# ADDENDUM No. 1

## ITB No. 4525

### CREST BUENA VISTA WASHINGTON WATER MAIN PROJECT

SHEET No. 41 OF 46

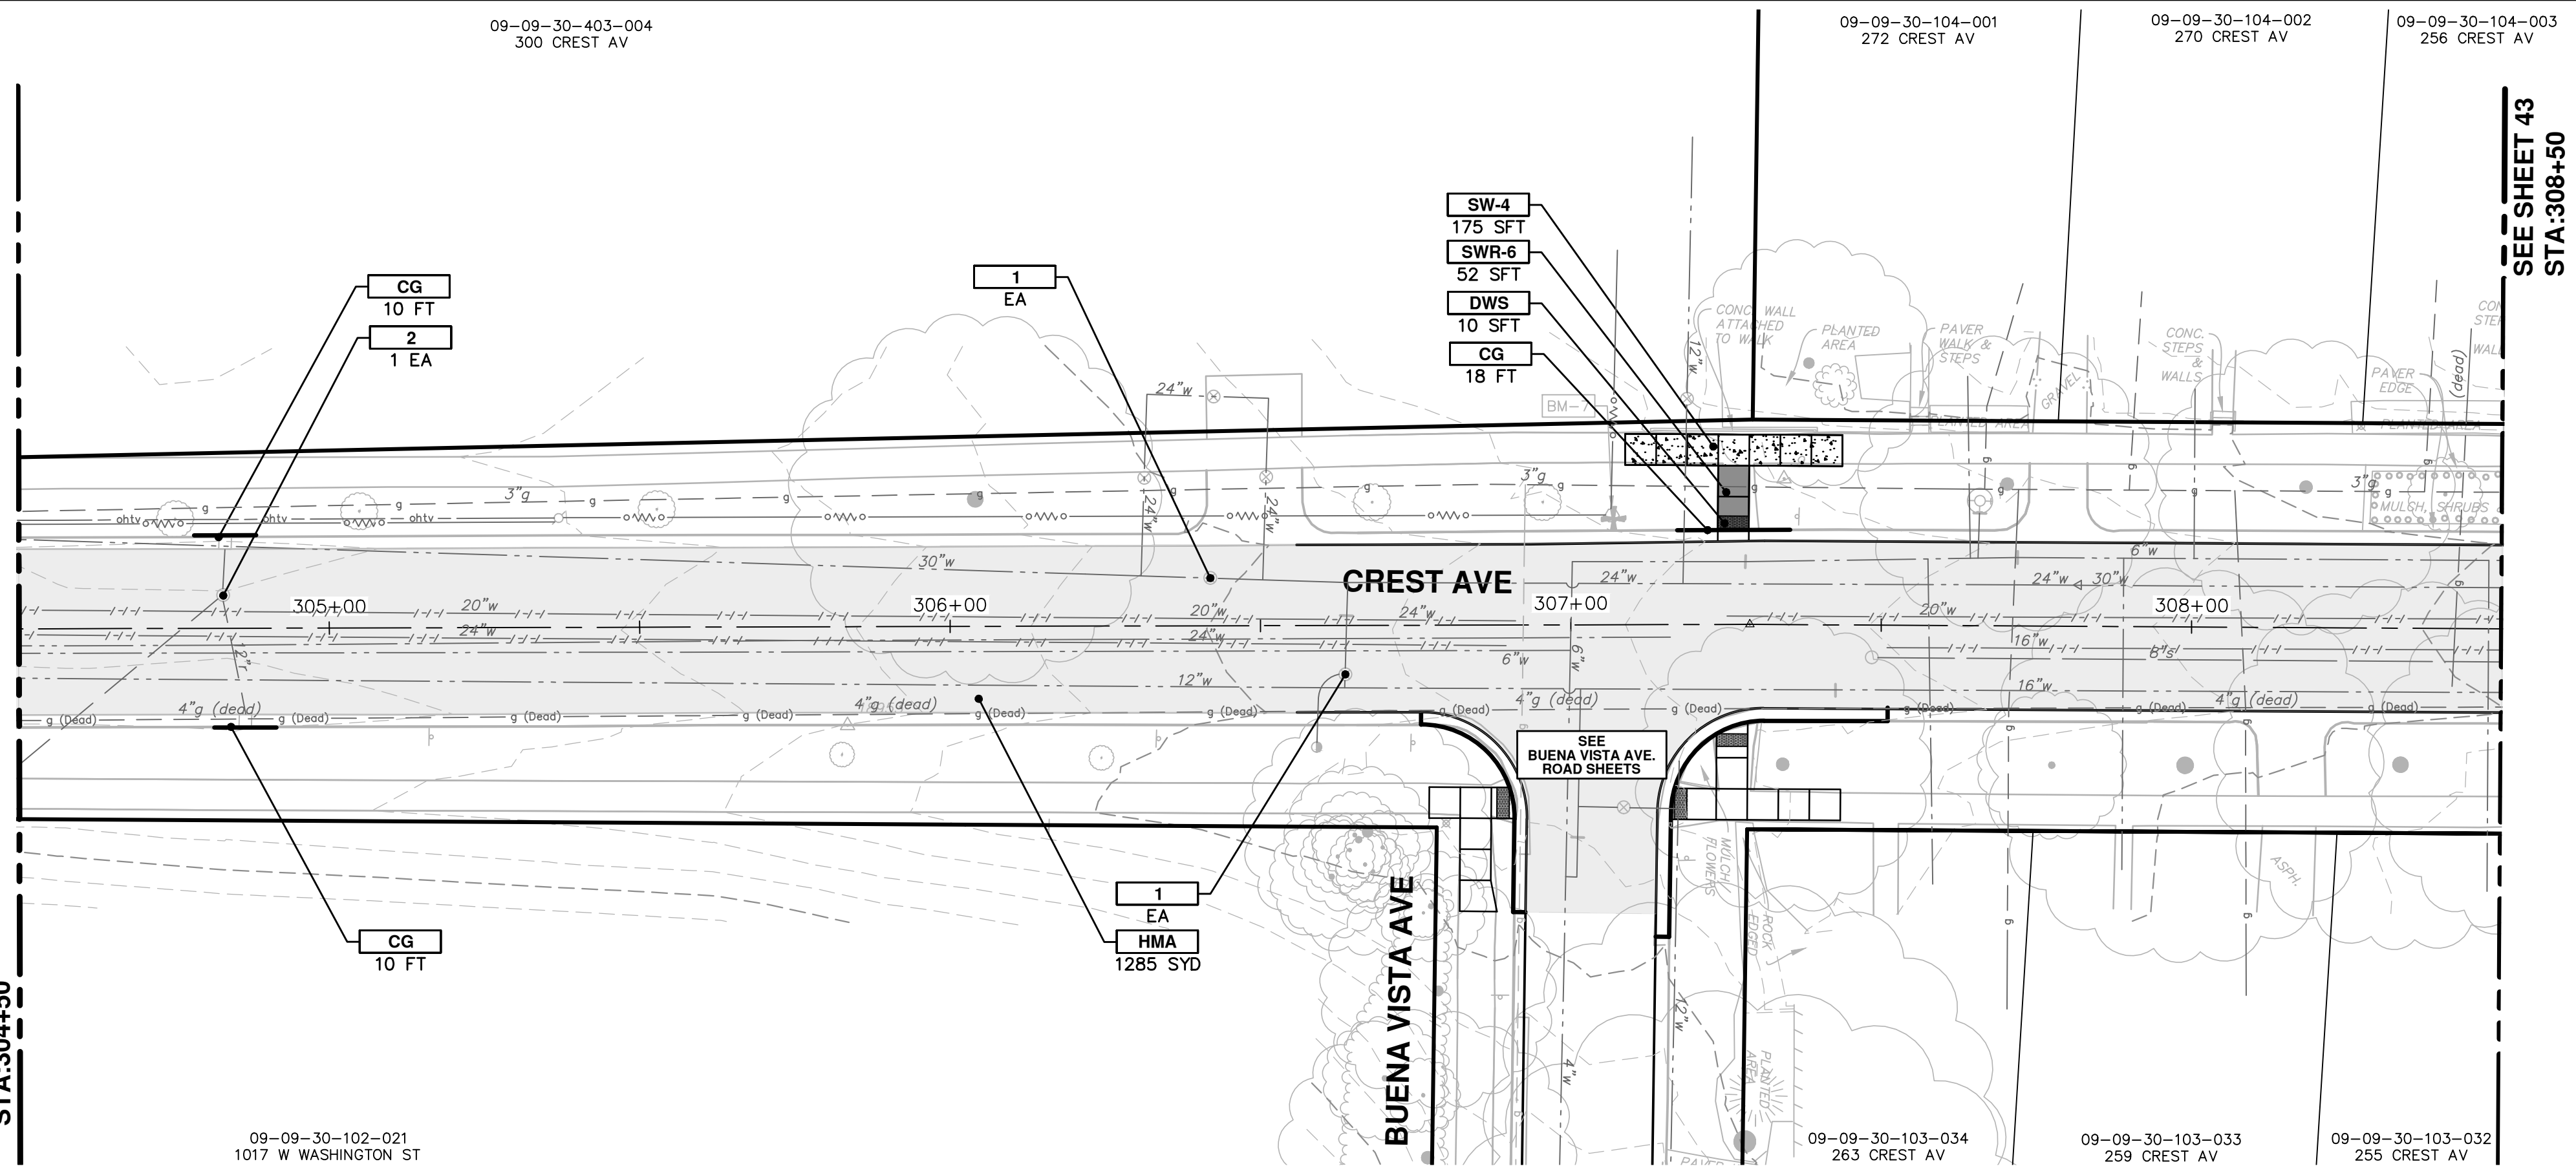
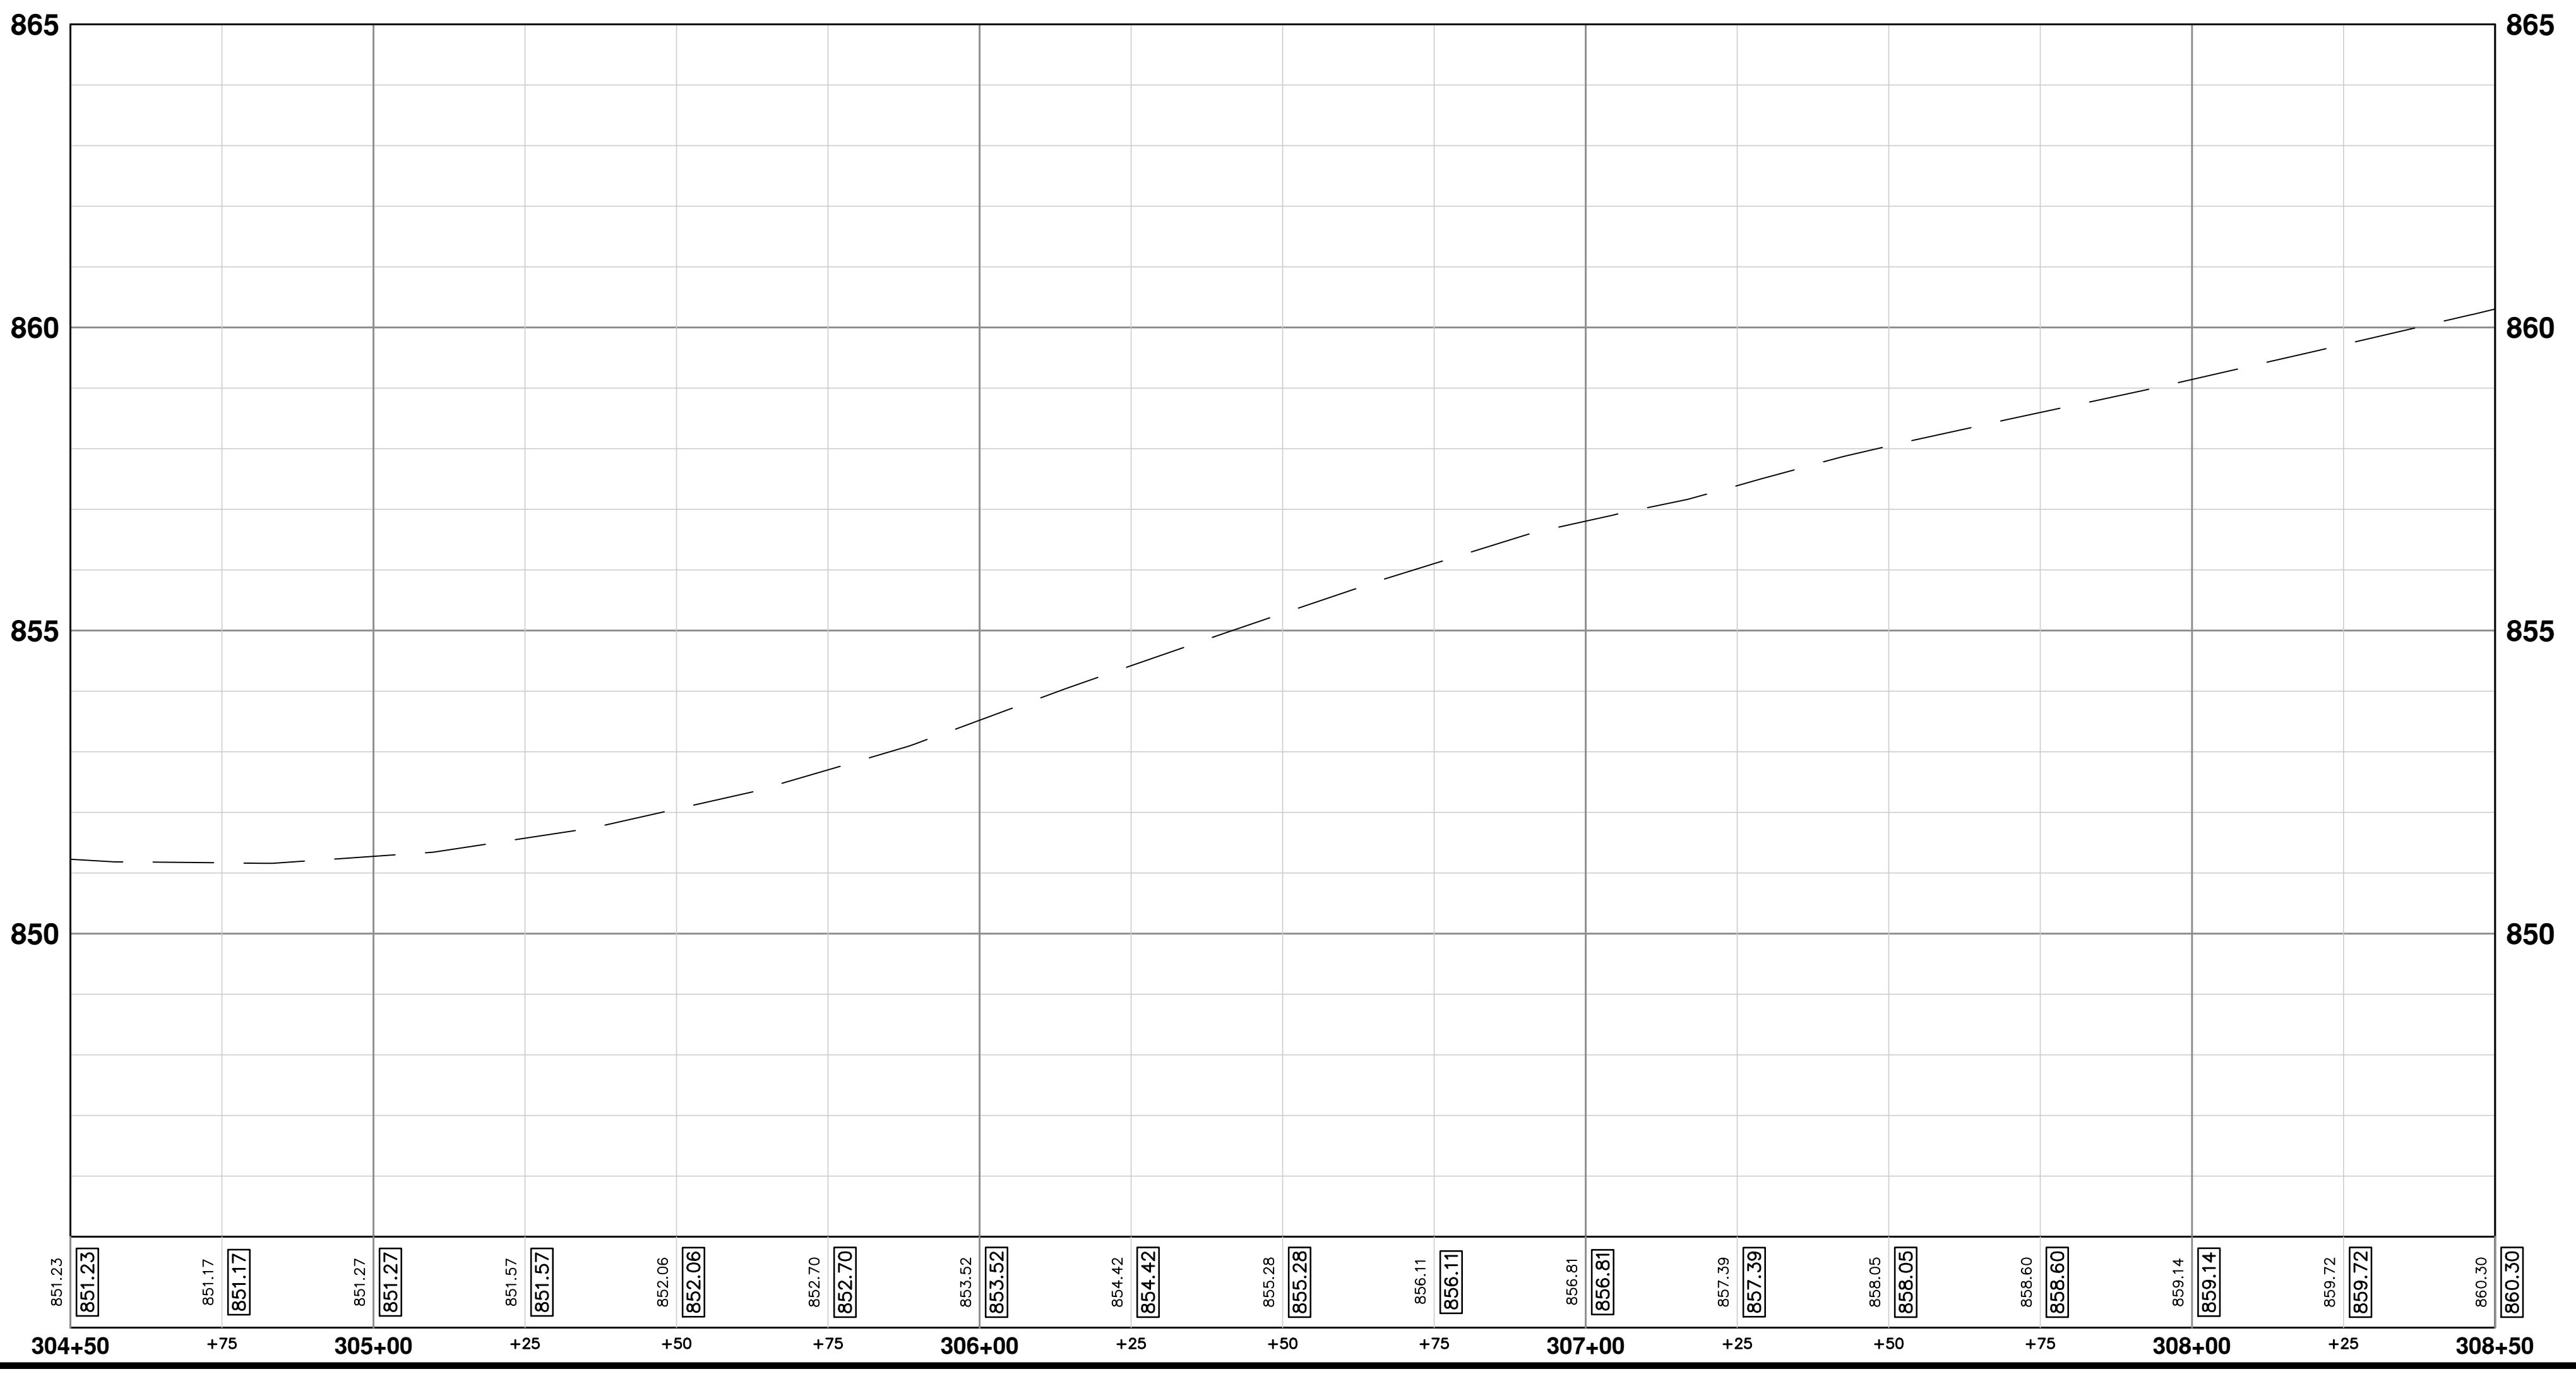
On plan sheets 39-45, structure and gate box adjustments were added.
